Metropolitan Planning Commission

Staff Reports

September 26, 2024

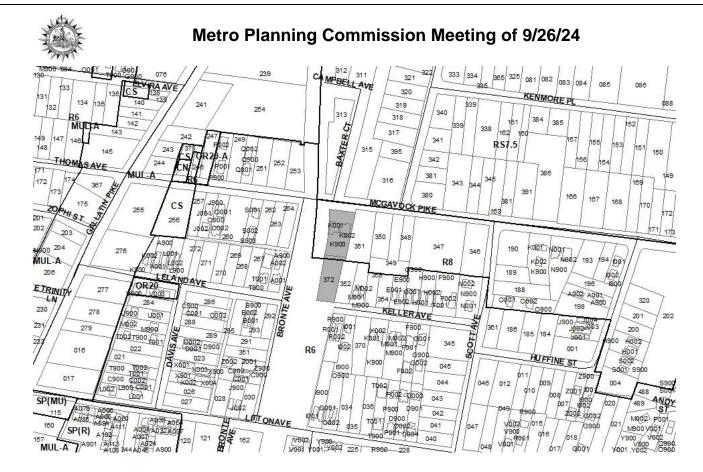
- 2. On the corrected set, update Landscape Standards Note #6 to say: A 20-foot-wide C-3 Landscape Buffer shall be provided at the rear of lots along the eastern property and between lots 1 and 90 and the cell tower. Behind lots 1 through 6, supplemental landscape planting will be determined at final site plan.

- 3. On the corrected set, add case number to the development summary on page 3.
- 4. On the corrected set, replace note 1 on page 12 with the use condition above.

- 5. On the corrected set, remove page 10 with the illustrative plan.
- 6. On the corrected set, update the side yard setback for corner lots based on the setback diagram on Sheet C1.01.

- 8. With the final site plan, the limits of disturbance and areas of preservation as identified on the preliminary SP plan on Sheet C1.01 shall not be modified without prior approval from Planning staff.

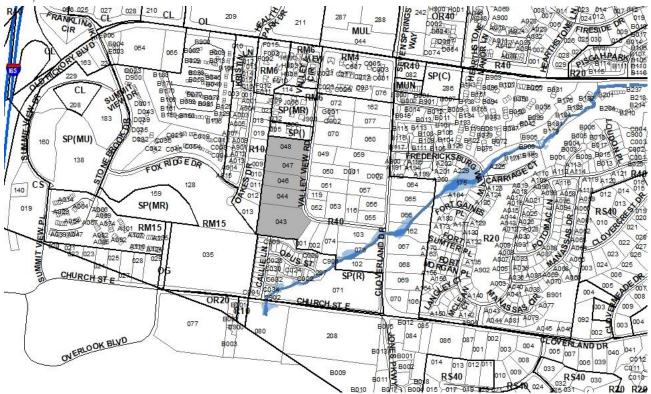
- 4. On the corrected copy, update the site plan on sheet C1.0 to reflect the stepbacks on the floor plans and elevations.
- 5. On the corrected copy, update the setbacks table under the site data table to be consistent with the setbacks proposed on the plan.
